Installation Update Lock-Right Model #1810 Manual Addendum #1000-760

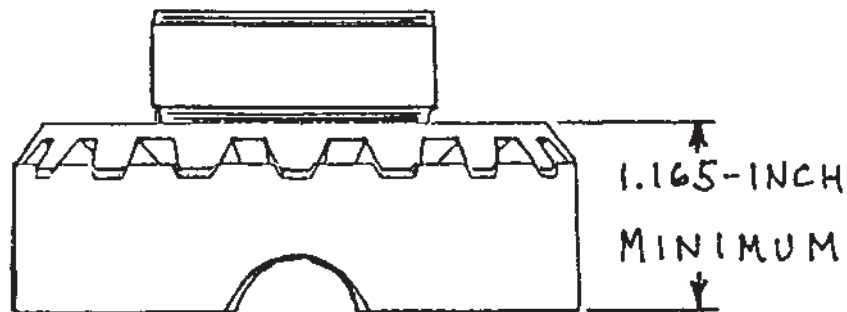
The thickness of the combination of only the side gear and Lock-Right driver (no thrust washer installed), with the teeth meshed, should be 1.165-inch minimum! If this measurement is under 1.165-inch, the Lock-Right will not operate properly, and the drivers and pins may become damaged.

Be sure to check this measurement with a micrometer or dial caliper before installation. If these instruments are not available, the combination may be placed on a table top and measured with a ruler. the combination should measure slightly less than 1-3/16 (1.188-inch). If this measurement is less than the minimum 1.165-inch, the gears are incompatible with your new Lock-right and the correct ones must be obtained before installation.

Note: For reference--we have found two different designs of incompatible side gears. One side gear and driver combination measures 1.107-inch thick, and the other combination measures 1.140-inch thick. Neither one will operate properly, as detailed above.
